SYDNEY NORTH PLANNING PANEL ASSESSMENT REPORT

Panel Reference	2017SNH050
DA Number	DA0014/17
LGA	Ku-ring-gai
Proposed Development	Demolition of existing structures and staged construction of a residential aged care facility, comprising 101 beds, basement car parking and associated landscaping works - State Environmental Planning Policy (Housing for Seniors or People with a Disability) 2004.
Street Address	12, 14 and 16 Trafalgar Avenue, Roseville
Applicant	KOPWA Ltd C/O Smyth Planning
Owner	KOPWA Ltd
Number of Submissions	Original DA: 13 submissions Amended DA: 4 submissions
Recommendation	Refusal
Regional Development Criteria (Schedule 7 of the SEPP (State and Regional Development) 2011)	General development with a CIV of more than \$30 million.
List of all relevant s4.15(1)(a) matters	<ul style="list-style-type: none"> • SEPP 55 – Remediation of Land • Draft Remediation of Land SEPP • SREP (Sydney Harbour Catchment) 2005 • SEPP (Housing for Seniors or People with a Disability) 2004 • State Environmental Planning Policy (State and Regional Development) 2011 • Ku-ring-gai LEP (Local Centres) 2012 • Ku-ring-gai Local Centres DCP • Ku-ring-gai Contributions Plan 2010 • Clause 92(1)(b

Figure 2 - Section through 3 storey portion of Stage 2 – the rear boundary is on the left side of the section

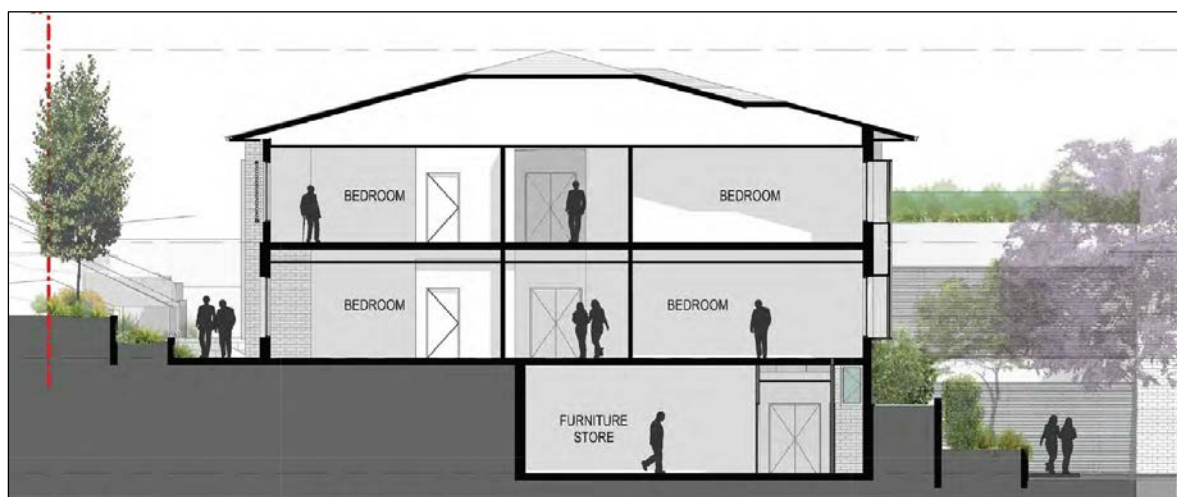
The applicant has submitted a clause 4.6 variation request to the 2 storey development standard in clause 40 (4) (b) of SEPP Seniors as part of Stage 2 contains three levels.

The SEPP states that a building that is adjacent to a boundary of the site must not be more than 2 storeys in height. The SEPP does not define the meaning of adjacent, however the dictionary meaning is, 'Lying near, close, or contiguous; adjoining; neighbouring'. The SEPP contains a note which states that the purpose of this standard is to avoid an abrupt change in the scale of
